ZAYO'S PRINEVILLE TO RENO PROJECT

CPUC MINOR PROJECT REFINEMENT FORM

RFI 450

VIEWPORT - 69

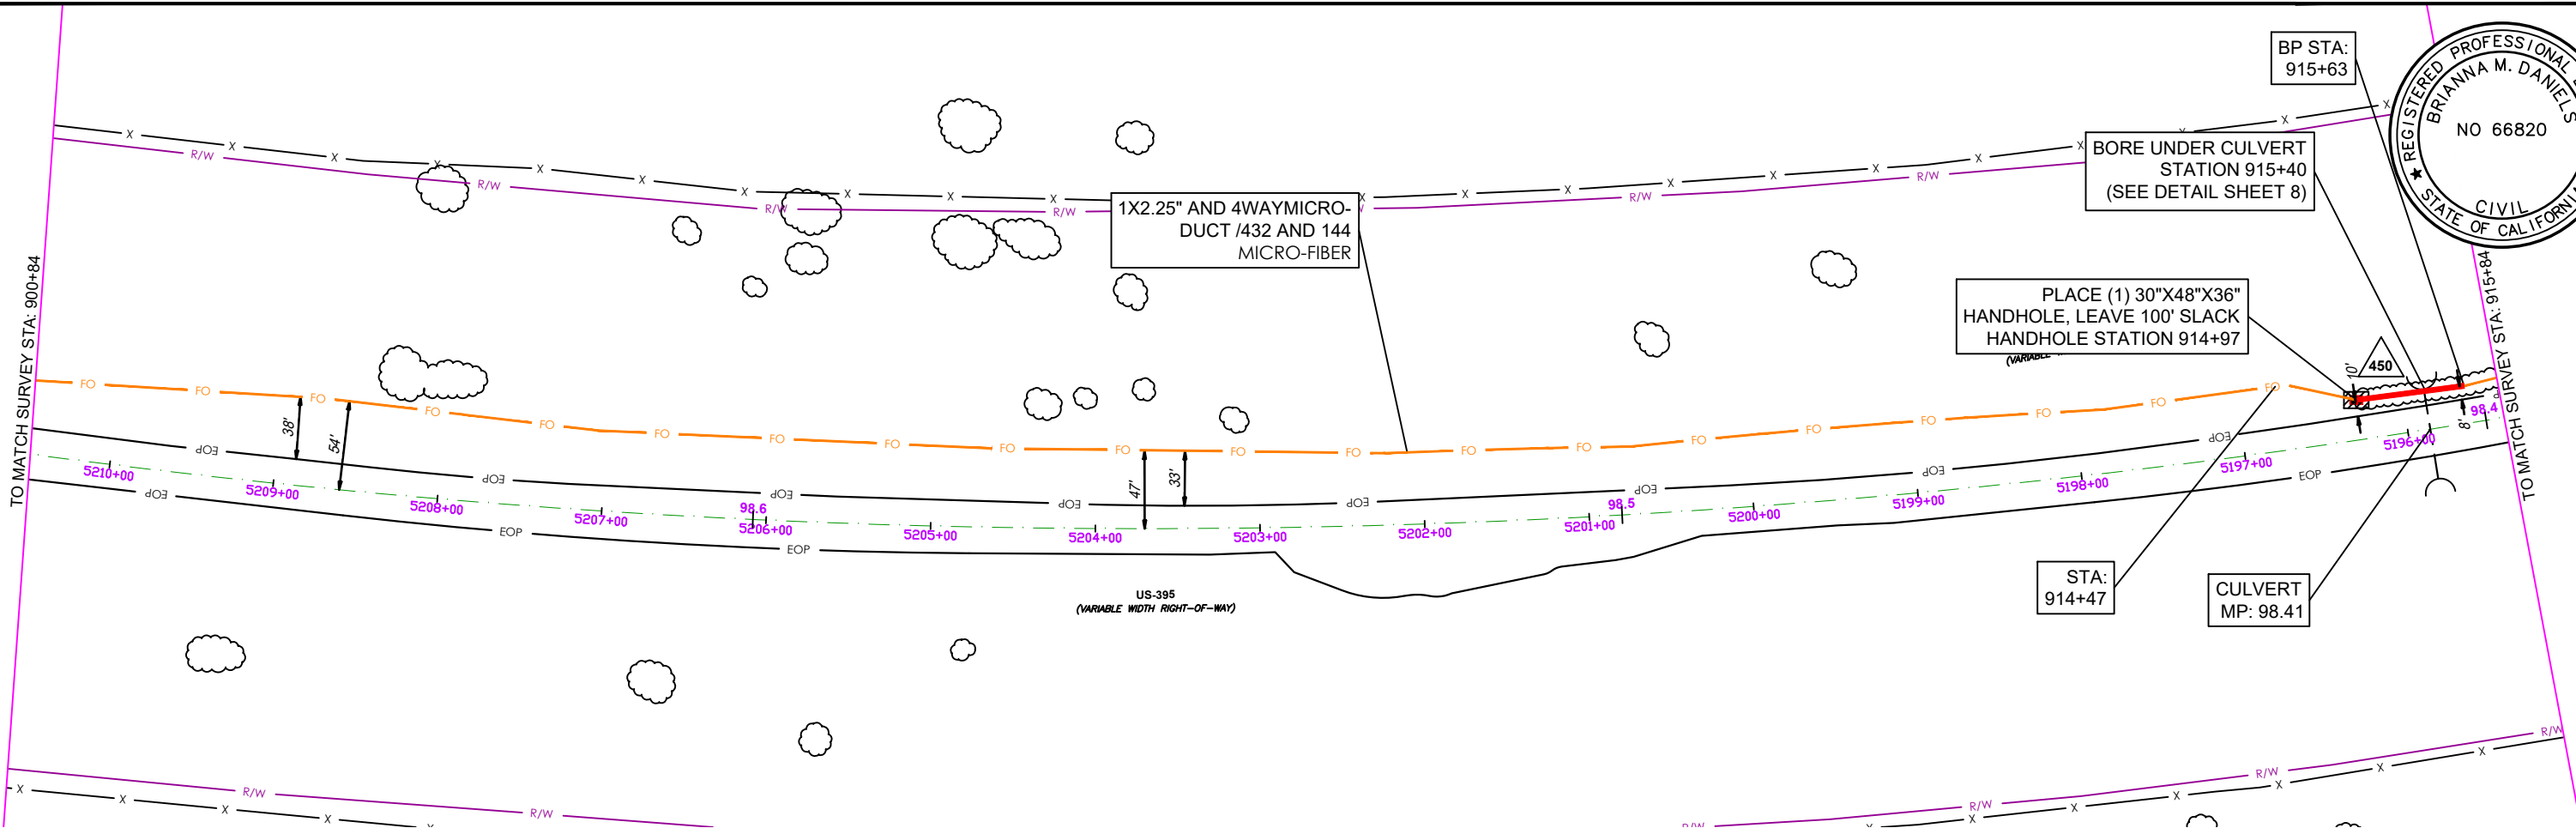
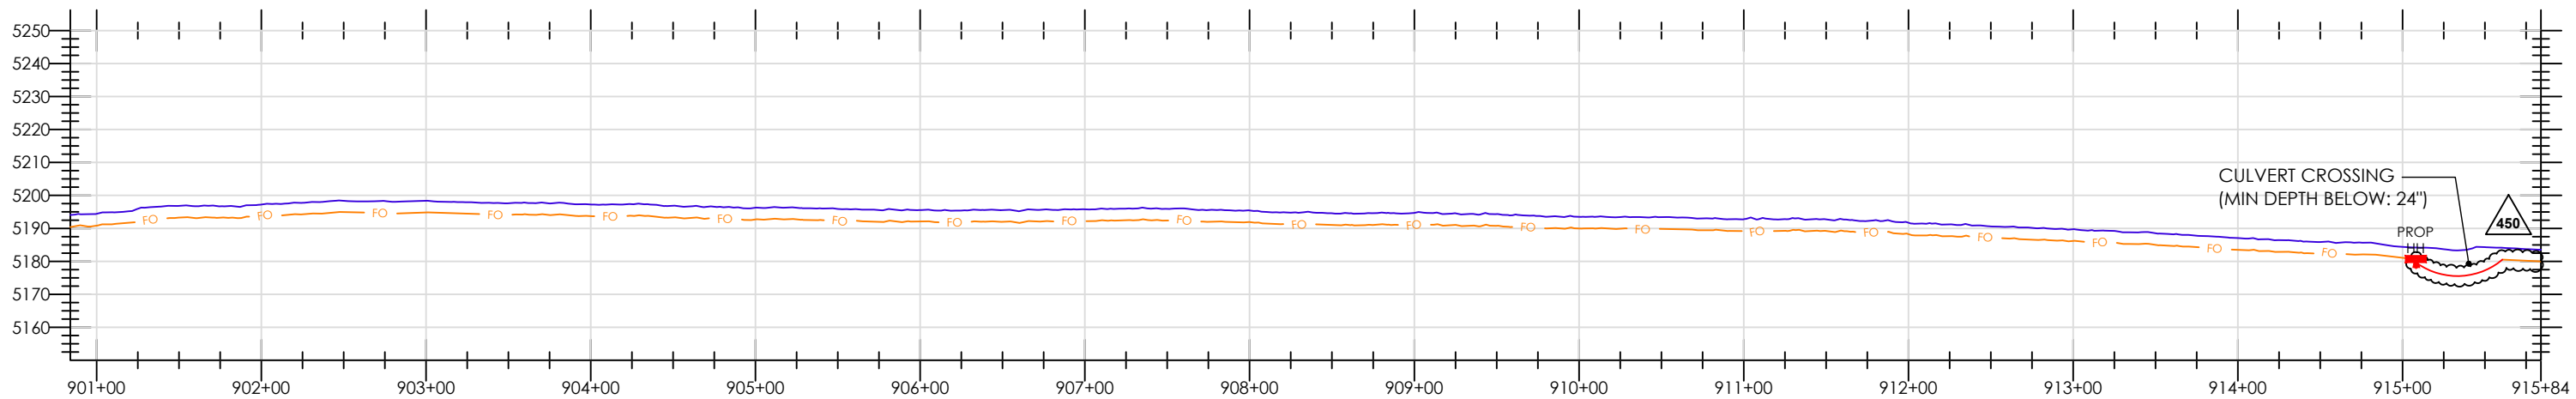
NOTES: FOR TRAFFIC CONTROL REFER TO 2023 CALTRANS STANDARDS AND LATEST EDITION OF CAMUTCD CAUTION RIGHTS-OF-WAY ARE DEPICTED BASED ON LATEST DOT RECORDS AVAILABLE. IF FURTHER ACCURACY IS REQUIRED, LAND SURVEYS WILL BE NECESSARY	RFI NO. 0450 DEVIATE R/L TO 10' FROM EOP OR TOE OF SLOPE STA 900+04 TO 905+88	12/16/2024

VIEWPORT - 70

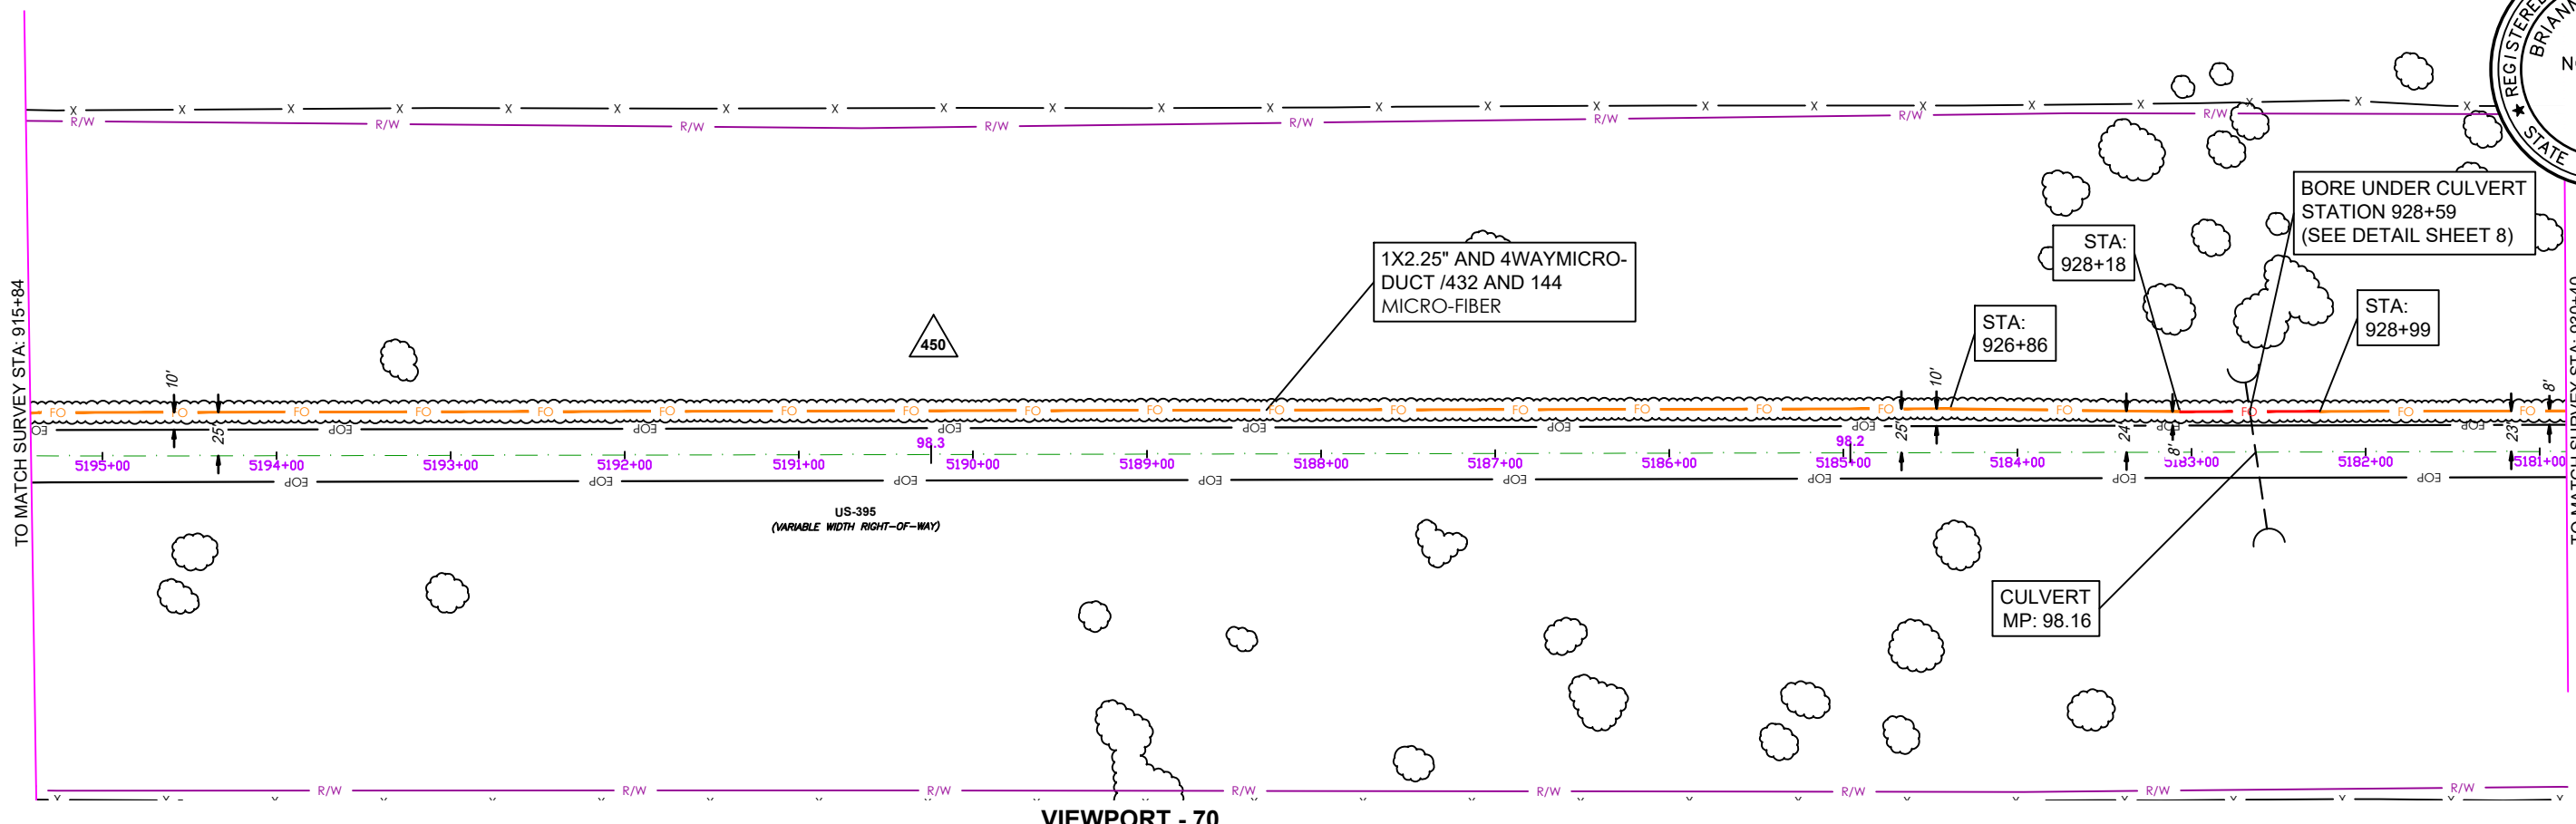
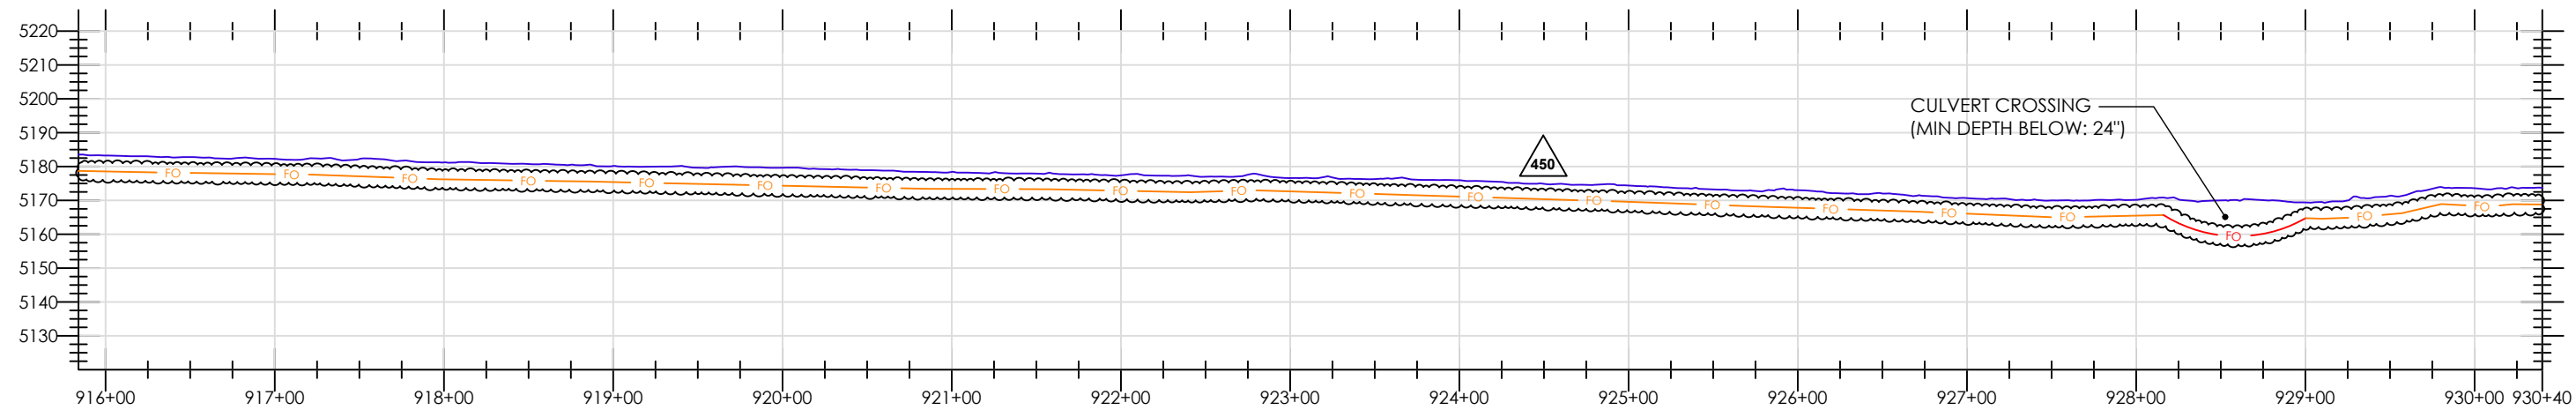
NOTES: FOR TRAFFIC CONTROL REFER TO 2023 CALTRANS STANDARDS AND LATEST EDITION OF CAMUTCD CAUTION RIGHTS-OF-WAY ARE DEPICTED BASED ON LATEST DOT RECORDS AVAILABLE. IF FURTHER ACCURACY IS REQUIRED, LAND SURVEYS WILL BE NECESSARY	RFI NO. 0450 DEVIATE R/L TO 10' FROM EOP OR TOE OF SLOPE STA 900+04 TO 905+88	12/16/2024

VIEWPORT - 71

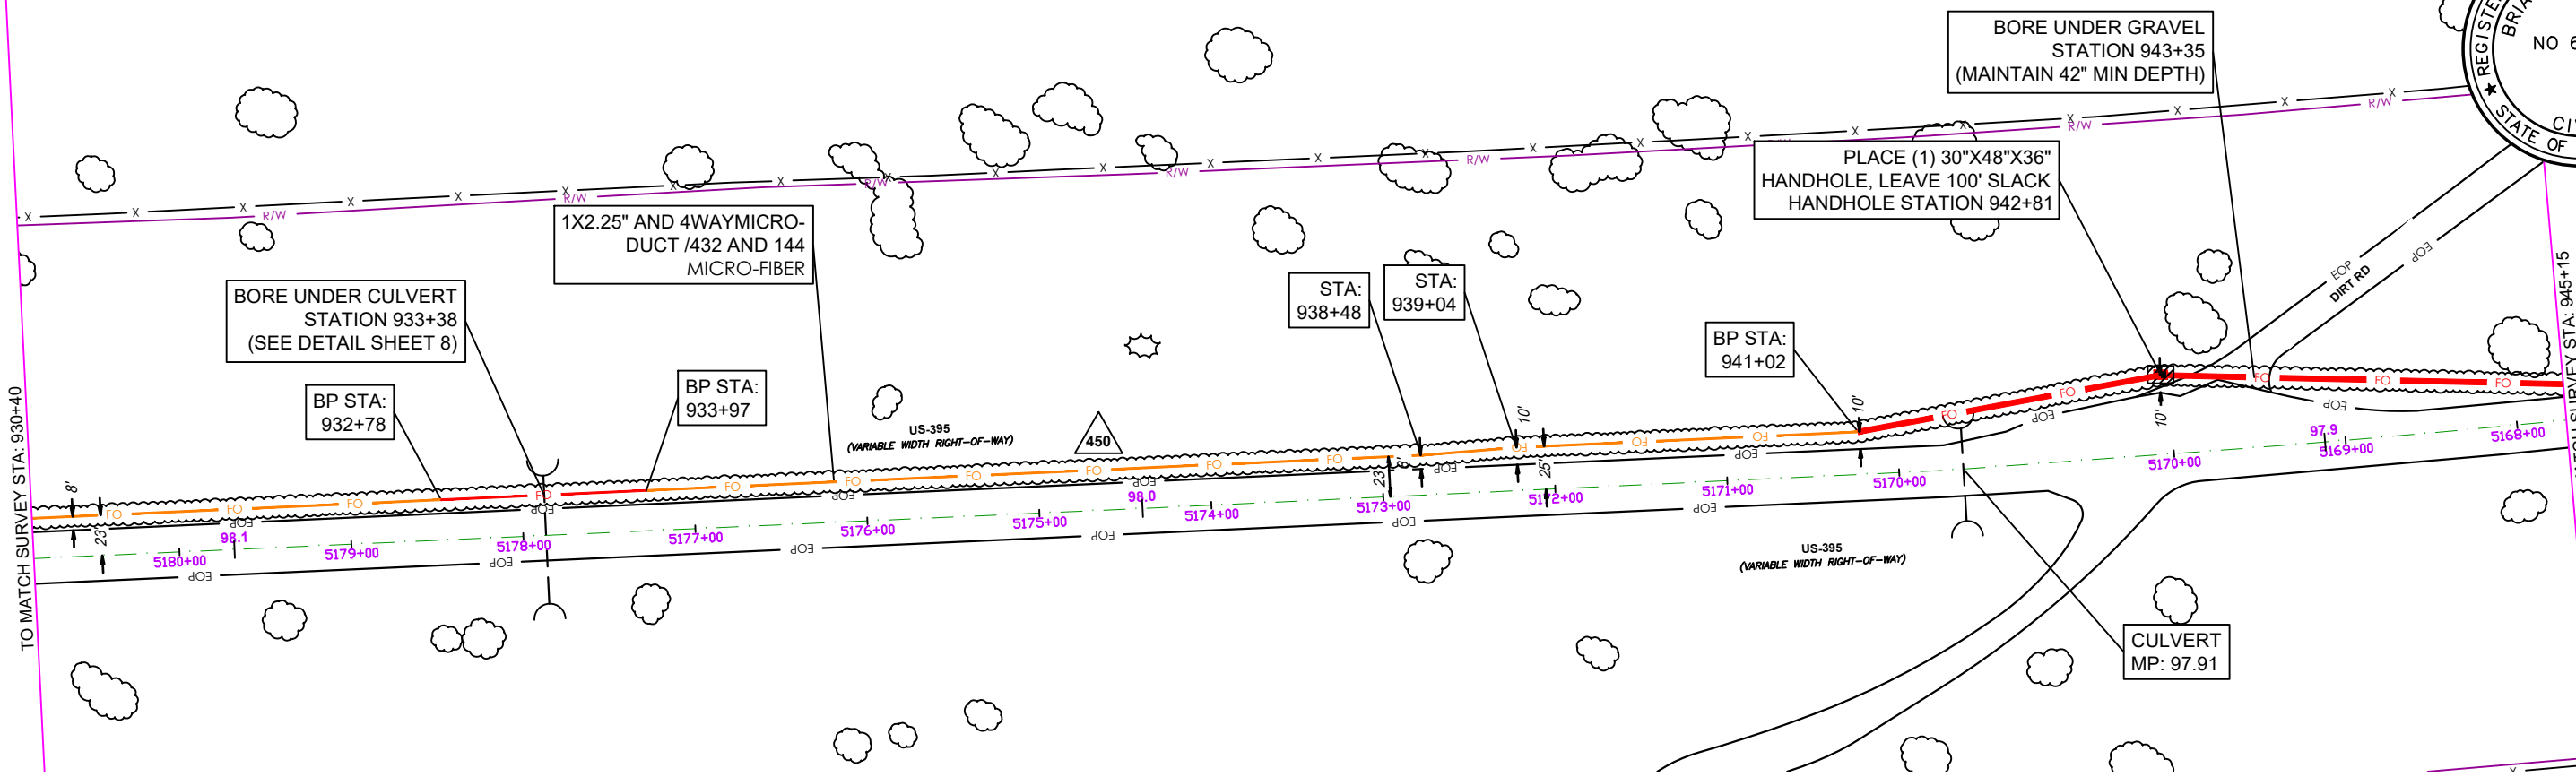
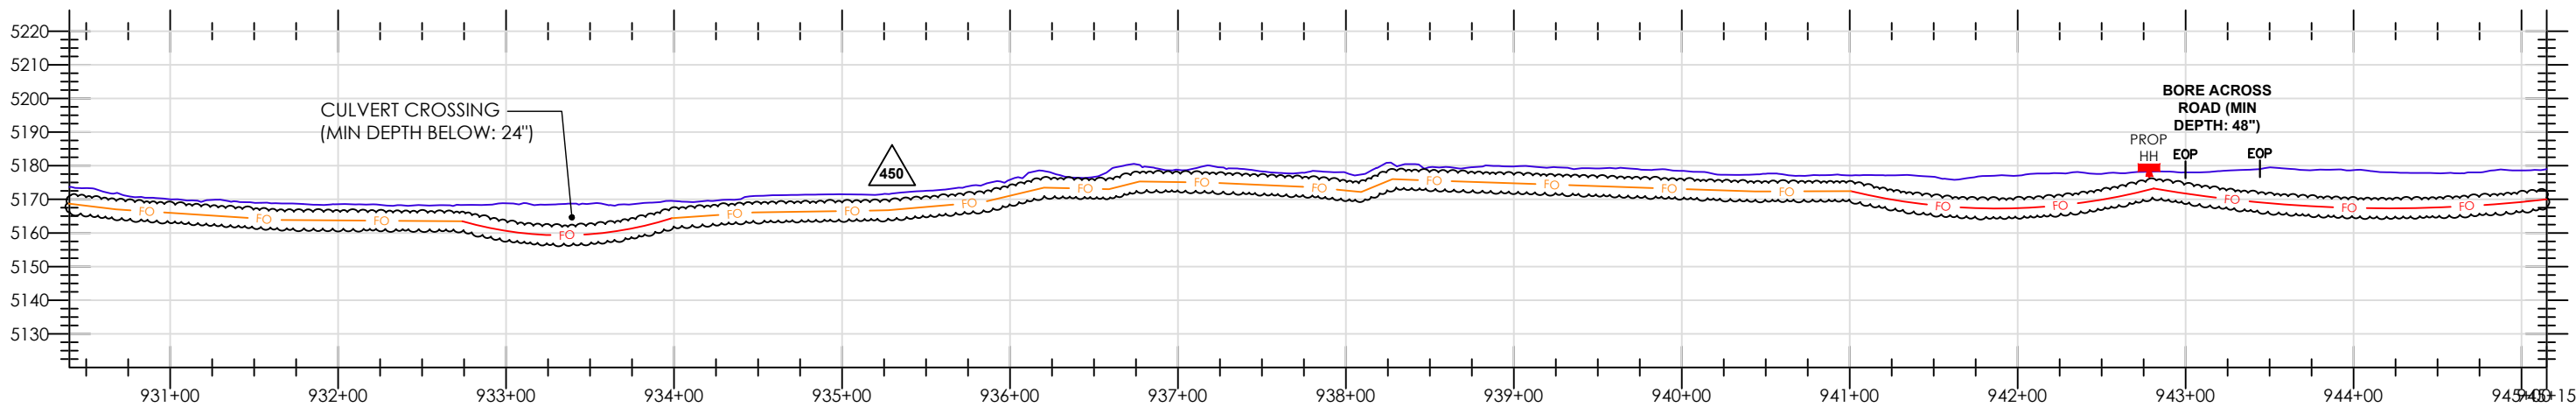
NOTES: FOR TRAFFIC CONTROL REFER TO 2023 CALTRANS STANDARDS AND LATEST EDITION OF CAMUTCD CAUTION RIGHTS-OF-WAY ARE DEPICTED BASED ON LATEST DOT RECORDS AVAILABLE. IF FURTHER ACCURACY IS REQUIRED, LAND SURVEYS WILL BE NECESSARY	RFI NO. 0450 DEVIATE R/L TO 10' FROM EOP OR TOE OF SLOPE STA 900+04 TO 905+88	12/16/2024
